URBAN DESIGN CONSULTATION RESPONSE

Design Officer	Azhar Kapadi
Date	13.07.26
Application Reference	25/01018/FUL
Address	Land At Waterfold Lane Heap Bridge Bury BL9 7JY
Proposal	Residential development of a 100% affordable housing scheme comprising of one, three storey block of 24 apartments and a row of 6 terraced dwellinghouses, alongside creation of access, landscaping, drainage and other associated works

Layout

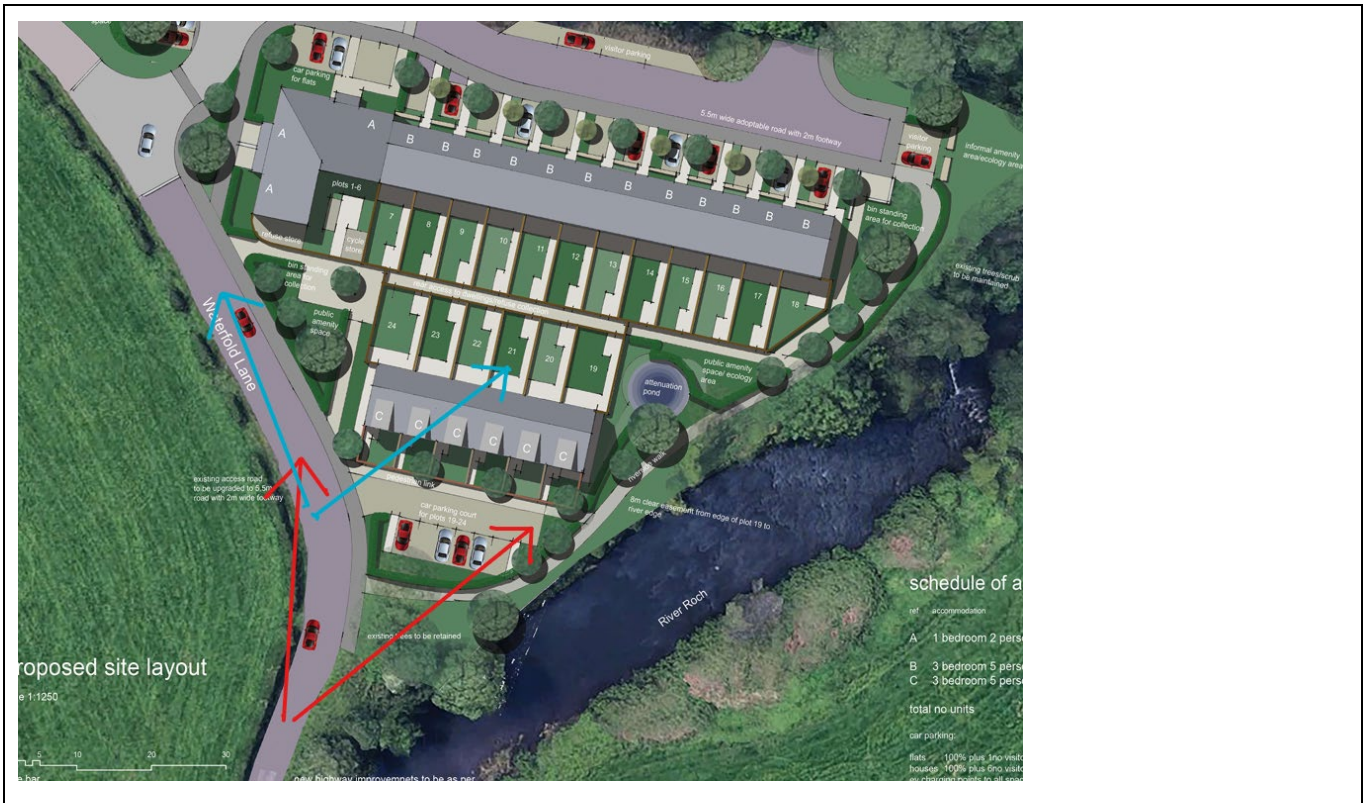
The scheme would function better as an organic layout, with houses fronting Waterfold Lane. This would be more in keeping with the immediate context which is partially rural despite featuring terrace rows. This would then be a natural continuation from dwellings that already exist on Waterfold Lane. That being said, there are six existing dwellings that are offset slightly at an angle away from the bend in the road so within reason there could be scope to accept something similar as per shown in this proposal.

Whilst the applicant has sought to screen elements previously identified as unsightly, such as parking areas, concerns remain. These issues are inherent to the site constraints and continue to affect the quality and appearance of the proposed development.

Even with additional landscaping, it is unlikely that tree planting would effectively screen features such as the large rear garden fences. By comparison, the boundary wall treatment proposed to the frontage of Block B is attractive and, if replicated along Block A, would create a far more positive and cohesive street frontage.

However, the prominence of the tall mixed fencing along Block A appears unavoidable and results in a frontage that is neither attractive nor well-related to the public realm. Consequently, the scheme fails to present the strong and active frontage that would normally be expected of a development of this nature.

As the development is approached further along Waterfold Lane, the visual impact of rear garden boundary treatments remains evident despite the proposed landscaping. Views would continue to include additional rear garden fencing together with an angled side/gable elevation of the apartment block. Greater confidence is required that these elements can be adequately softened, supported by detailed tree specifications and additional sectional drawings demonstrating the effectiveness of the proposed screening.

The scheme appears to prioritise a frontage towards the M66, which is difficult to reconcile with the site's context. There are more attractive and valuable outward views away from the motorway towards the surrounding area, yet these opportunities have not been fully utilised or reflected in the layout and orientation of the development.

Block B presents a positive frontage through the use of an attractive boundary wall treatment. However, the benefits of this approach are undermined by a layout that is heavily reliant on frontage parking, which in turn dominates the building elevations. Whilst these views may be experienced primarily by residents of the block, they nevertheless fall short of demonstrating high-quality design.

More generally, the extent of frontage parking across the site is excessive and becomes a defining feature of the proposal. The cumulative impact is a car-dominated environment that detracts from the quality of the public realm and weakens the overall design approach.

The informal amenity space is awkwardly arranged and does not appear particularly usable. The inclusion of two parking spaces within this area feels like an afterthought and further compromises its function.

Whilst the constraints of the site are acknowledged, they have clear consequences for the quality of the design. The 3m-high acoustic fences required within the centre of the site are likely to be prominent and visually intrusive. As a result, views from parts of the development are likely to comprise little more than a series of high acoustic fences, creating an enclosed and engineered environment.
